ENGINEERING INSTRUCTION

NEW YORK STATE DEPARTMENT OF TRANSPORTATION

SUBJECT: BITUMINIZED FIBER PULLBOXES AND RIGID
PLASTIC CONDUIT FOR TRAFFIC SIGNALS

Code: EI 80-8

CIRCULAR BITUMINIZED FIBER PULLBOX

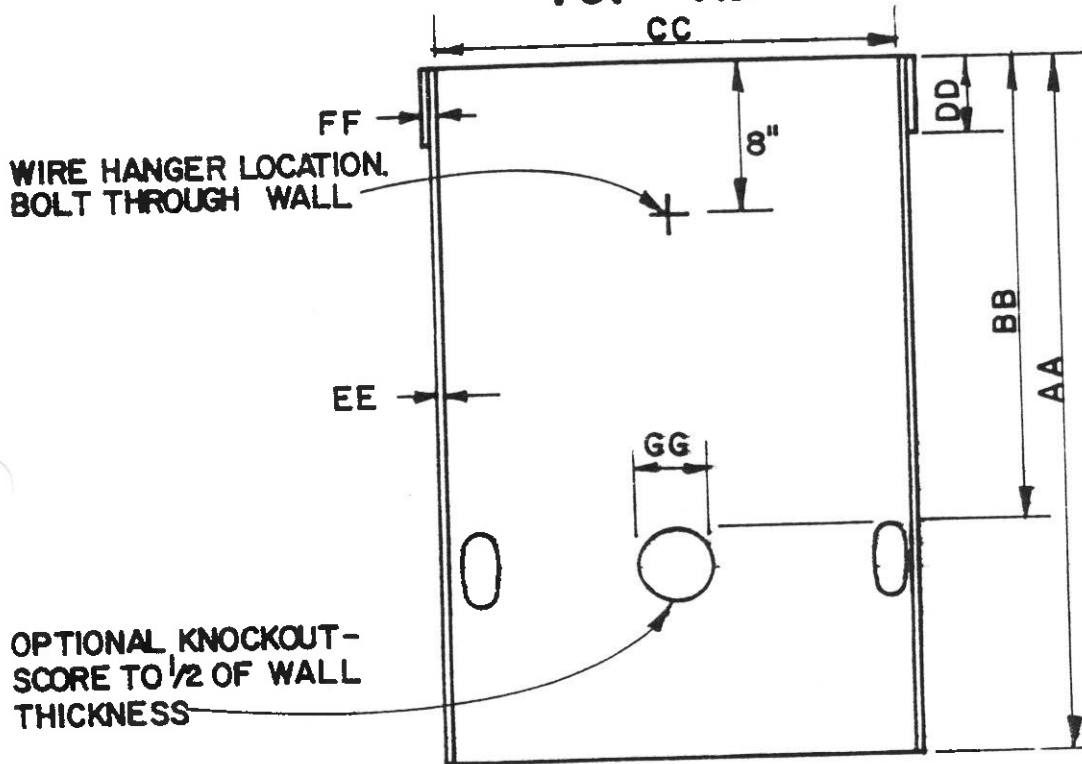
Make the following changes to Standard Sheet 680-11:

1. Add the attached detail on "Circular Bituminized Fiber Pullbox" to Standard Sheet 680-11.
2. Add the following to Standard Sheet 680-11 under GENERAL NOTES:
 8. THE FRAME AND COVER FOR CIRCULAR PULLBOXES SHALL BE USED FOR BOTH REINFORCED CONCRETE AND BITUMINIZED FIBER PULLBOXES.
